Product Change Notice (PCN)

PCN Number: **PCN-0454915-01**

Product(s) Affected: *PJ-096H*

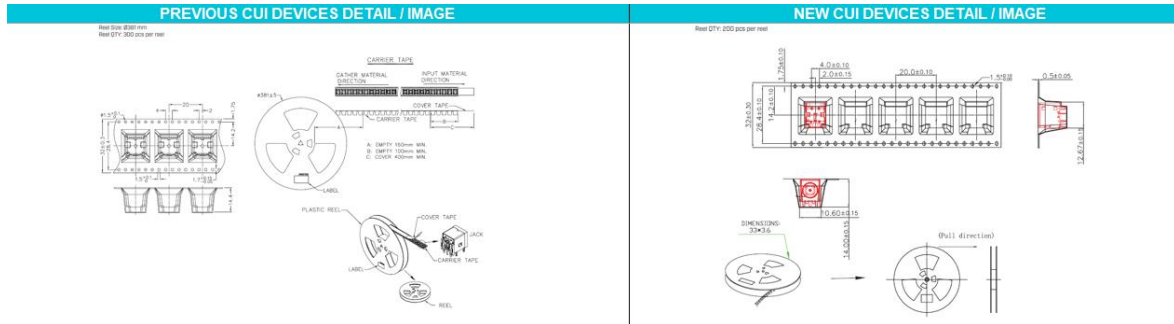
Description of Change: *Minor Housing and footprint differences. Material Change on the housing and terminals. See image Below*

PREVIOUS CUI DEVICES DETAIL / IMAGE			NEW CUI DEVICES DETAIL / IMAGE		
	MATERIAL	PLATING	DESCRIPTION	MATERIAL	PLATING/COLOR
terminal 1	copper alloy	gold flashed	terminal 1	copper alloy t=0.30	gold flash over nickel
terminal 2	copper alloy	gold flashed	terminal 2	copper alloy t=0.30	gold flash over nickel
terminal 3	copper alloy	gold flashed	terminal 3	copper alloy t=0.30	gold flash over nickel
terminal 4	copper alloy	gold flashed	terminal 4	copper alloy t=0.30	gold flash over nickel
spring	stainless steel		shield	brass t=0.35	nickel
shield	brass	nickel	insulator	LCP [UL94V-0]	black
insulator	PA10T

MATING PLUG
Jack Insertion Depth **9 mm**

MATING PLUG
Jack Insertion Depth **9.1 mm**
